**VIRGINIA ELECTRIC AND POWER COMPANY**  
**SURRY POWER STATION (SPS) UNITS 1 AND 2**  
**SUBSEQUENT LICENSE RENEWAL APPLICATION**  
**RESPONSE TO REQUESTS FOR ADDITIONAL INFORMATION**  
**SET 1 – REGARDING ENVIRONMENTAL REVIEW**

**RESPONSE TO RAIS**  
**SET 1 REGARDING SPS SLRA ENVIRONMENTAL REVIEW**

**Virginia Electric and Power Company  
(Dominion Energy Virginia or Dominion)  
Surry Power Station Units 1 and 2**

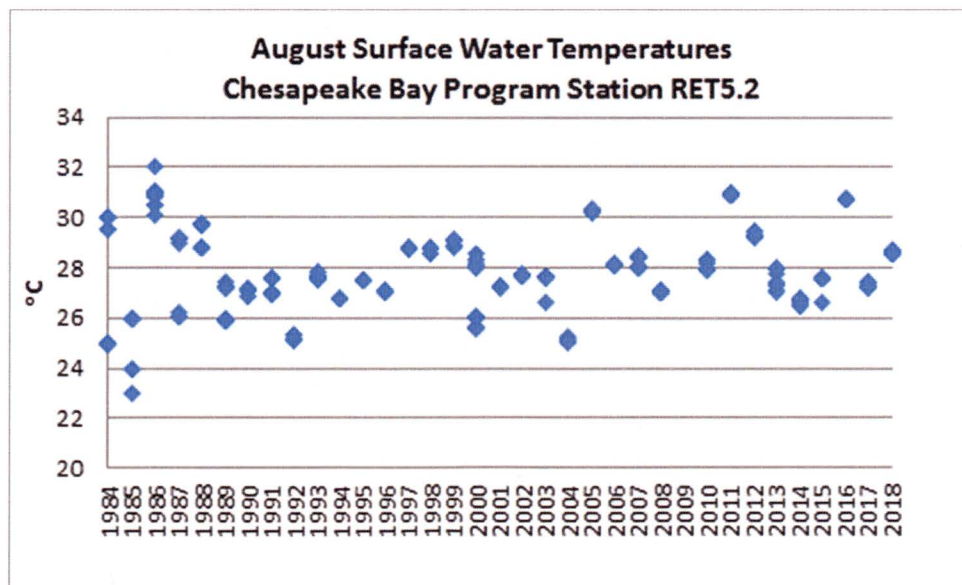
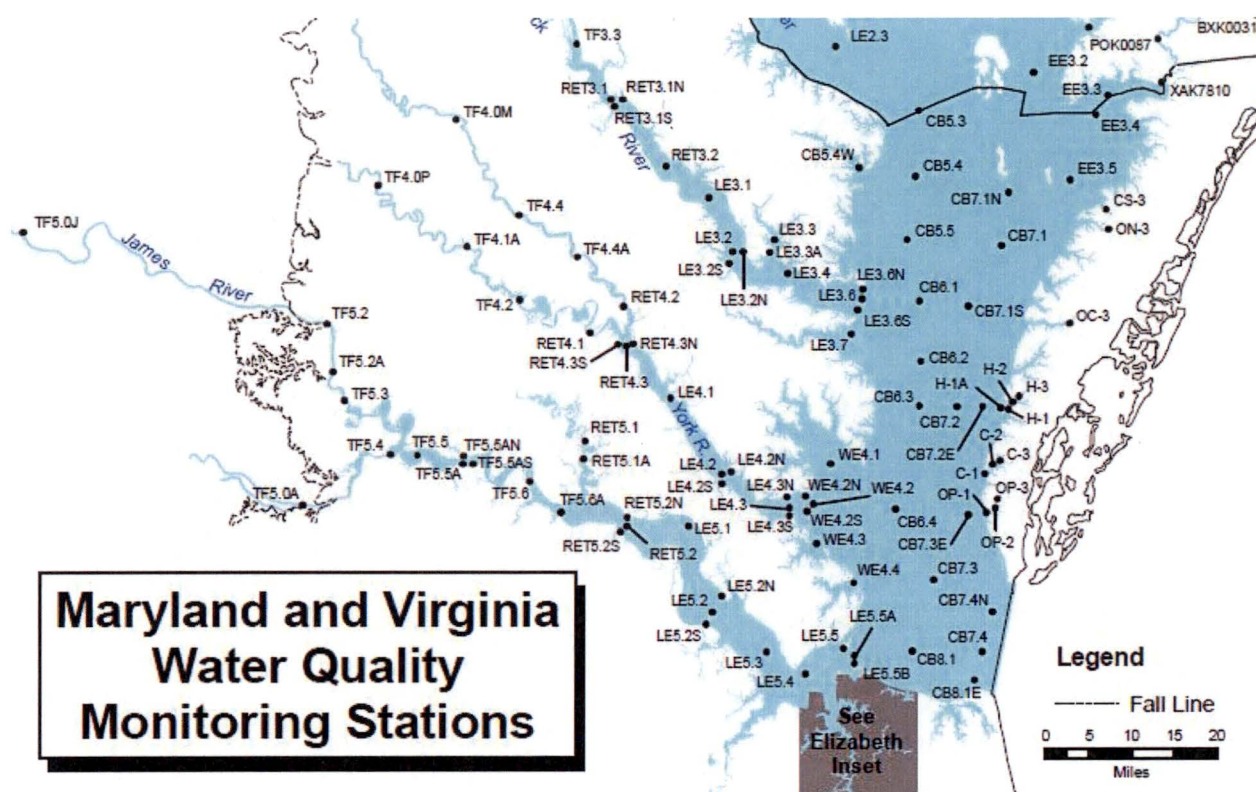
Section E2.2.3.2 of the ER discusses thermal effluent dispersion for the discharge canal. The ER states: "During a period of high ambient water temperatures (August 6 to September 10, 1975) when SPS was running at 90% or greater capacity, discharge temperatures ranged from 92.8°F to 99.9°F. These temperatures are believed to be typical of those observed in the discharge canal in late summer when both SPS units are operating at or near full power (Reference: SPS. 2001, Section 3.1.2.1). There are no changes since the 2010 uprate. Temperatures immediately outside the discharge canal in the James River are lower, with the effluent losing 1-2°F with every 1,000 feet from the mouth of the discharge canal (Reference: SPS. 2001, Section 3.1.2.1)." Section E3.6.3.1 of the ER states: "After passing through the condensers and the service water system, most of the water is returned to the James River. Less than 22,000 gpm is lost to evaporation, approximately 1% of the initial intake. (VDEQ. 2013a)." In a Clean Water Act 316(b) demonstration for SPS, the maximum temperature rise of water across the condensers was reported to be 7.8 °C (VEPCO 1980; ML020230042). The thermal studies, evaporation rate, and maximum temperature rise of water across the condensers do not account for any additional thermal loading as a result of SPS 2010 power uprate.

- a. Provide a basis for concluding the 1975 high ambient water temperatures recorded are representative of the discharge canal in late summer under current SPS operating conditions.

- b. Provide a basis for concluding there have been no changes in discharge temperatures (both in the canal and James River). If current discharge temperatures are available (in the discharge canal or James River), please provide these and identify the location where the temperatures were taken (e.g., in the discharge canal; in the James River at a certain distance from the discharge canal, etc.).

- a. In 1975, a study was performed during August to determine temperatures within the SPS thermal mixing zone. The survey was conducted during slack before ebb and slack before flood tidal conditions during a period when the station had been operating at near full capacity for several days. Background temperatures of 29.6°C and 28.7°C (85.6°F and 83.7°F) were measured in the James River during the study at a location close to Chesapeake Bay Monitoring Program station RET5.2. Both temperatures are very close to maximum historical James River temperatures measured at station RET5.2 indicating that the survey reflects close to maximum expected mixing zone temperatures.

Below is a figure showing James River temperatures measured during August of each year 1985–2017 at a Chesapeake Bay Program monitoring station RET5.2 that is located upriver from SPS (see map below). The station is located outside of the influence of Surry's thermal mixing zone.

FIGURE 1

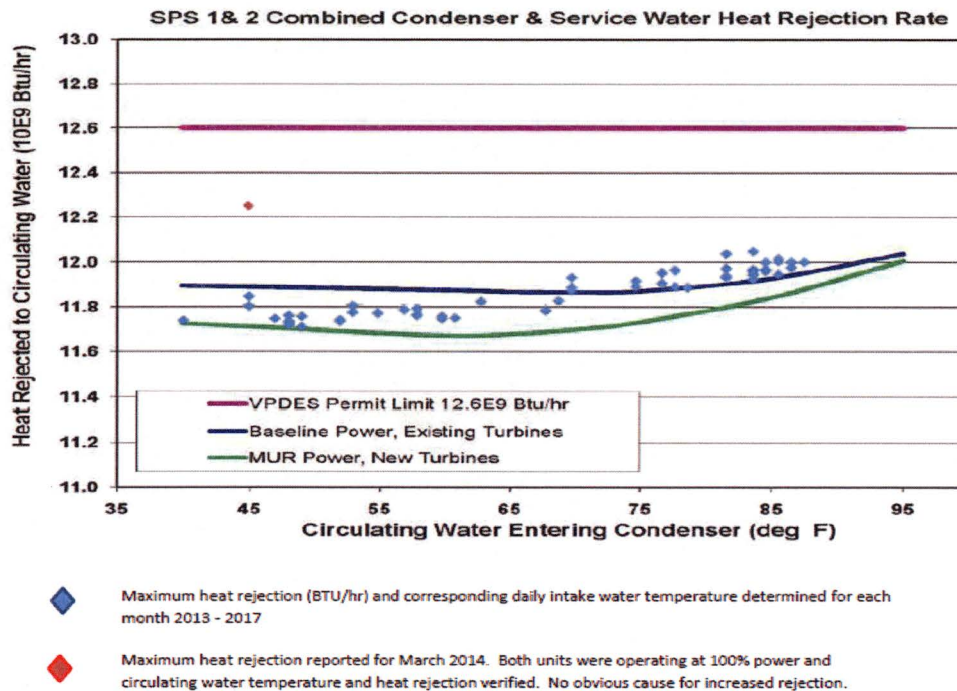
- e. *Has there been a change (increase or decrease) in the temperature rise of water across the condensers under current operating conditions of SPS and as a result of SPS power uprates? If so, please discuss. If there has been no change in maximum temperature rise of water across the condenser under current SPS operating conditions, provide a basis for concluding this.*

- e. Prior to implementation of the Measurement Uncertainty Recapture (MUR) Power and Alstom Turbine (TRP) uprates in 2010 and 2011, the impacts to waste heat rejection (BTU/hr) and resulting discharge temperature were evaluated using the Performance Evaluation of Power Station Evaluation (PEPSE) heat balance model for SPS 1 & 2. The PEPSE model was modified to reflect the MUR and TRP uprates using a maximum cooling water intake temperature of 95 degrees.

The analysis projected that implementation of the MUR uprate alone would result in an increase in the full plant thermal discharge to the James River from a baseline of  $12.04 \times 10^9$  BTU/Hour to approximately  $12.26 \times 10^9$  BTU/Hour. However, under TRP uprate conditions, the efficiency of the steam turbine, generator and condenser system to convert thermal energy originating from the reactor into electric power at the switchyard would be improved over that of the existing Siemens steam turbines. Consequently, evaluation of the combined MUR and TRP uprates projected that the TRP uprate would decrease the MUR heat rejection load from  $12.26 \times 10^9$  BTU/Hour to  $12.11 \times 10^9$  BTU/Hour.

Figure 1 compares the heat rejection rates projected to result from the MUR and TRP uprates (MUR Power, New Turbines) with the heat rejection rates existing prior to implementation of the uprates (Baseline Power, Existing Turbines). Figure 1 was discussed with VADEQ during a presentation given on January 10, 2010 prior to the uprates. At that time the analyses had indicated that implementation of the MUR and TRP uprates would result in a reduction in heat rejection from baseline for condenser inlet temperatures throughout the range from 40°F to 95°F. Because cooling water volumes were not impacted by the uprates, a decrease in water temperatures would also be predicted throughout this range.

Superimposed on Figure 1 (diamonds) are actual maximum heat rejections (BTU/hr) and corresponding daily intake temperatures determined for each month from 2013 – 2017. These data suggest the following:
